Access Compliance Report

Public Rights-of-Way

Intersection ID: 28367	Main Street: SOUTHAMPTON COMMONS DR	Cross Street: TRAVIS GULCH DR	Location: NE
ADA ID: 12BAA9394F36	Ramp Type: PerpDiag	Initial Pass/Fail: Fail	Overall Compliance: No
Severity Score: 12.5			
Codes/Mitigation Info/Possible Solution		Field Measurements/Component Compliance

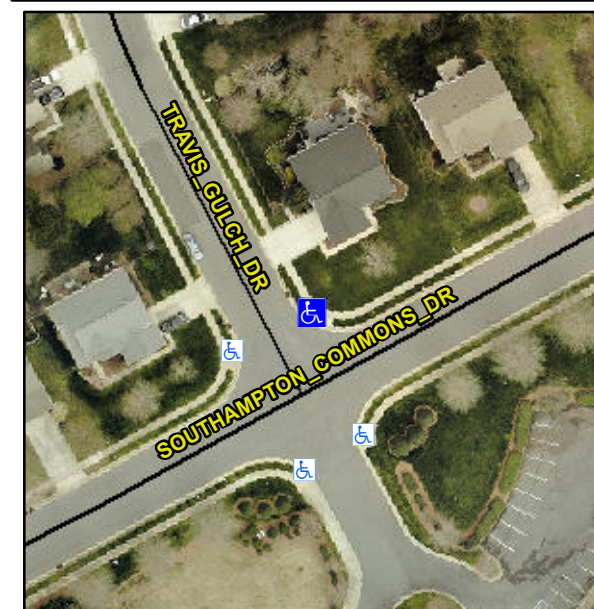
Not Found, R304.2.2

Compliance	Description	Data	Compliance	Description	Data
N/A	Ramp Length (in)	46.5	No	Ramp Slope (%)	8.7
Yes	Ramp Width (in)	73.0	Yes	Ramp XSlope (%)	1.7
N/A	Flare Type LT	N/A	N/A	Flare Type RT	N/A
N/A	Flare Slope LT (%)	N/A	N/A	Flare Slope RT (%)	N/A
N/A	Flare Traversable LT?	N/A	N/A	Flare Traversable RT?	N/A
N/A	Landing Length (in)	N/A	N/A	DWS Provided?	N/A
N/A	Landing Width (in)	N/A	N/A	DWS Contrast?	N/A
N/A	Landing Slope (%)	N/A	N/A	DWS Length (in)	N/A
N/A	Landing X Slope (%)	N/A	N/A	DWS Full Width?	N/A
N/A	Landing Curb? (Y/N)	N/A	N/A	DWS Offset (in)	N/A
N/A	Shared Landing?	N/A			
N/A	Gutter Ponding?	N/A	N/A	Gutter Slope (%)	N/A
N/A	Gutter Lip Ht (in)	N/A	N/A	Gutter X Slope (%)	N/A
N/A	Painted X Walk1?	No	N/A	Painted X Walk2?	No
	X Walk 1 Direction	To W		X Walk 2 Direction	To S
N/A	X Walk 1 Width (in)	N/A	N/A	X Walk 2 Width (in)	N/A
	X Walk 1 Slope (%)	2.7		X Walk 2 Slope (%)	0.8
	X Walk 1 X Slope (%)	1.4		X Walk 2 X Slope (%)	2.2

Remove & Replace Curb Ramp With Two New Directional Ramps or Equivalent.
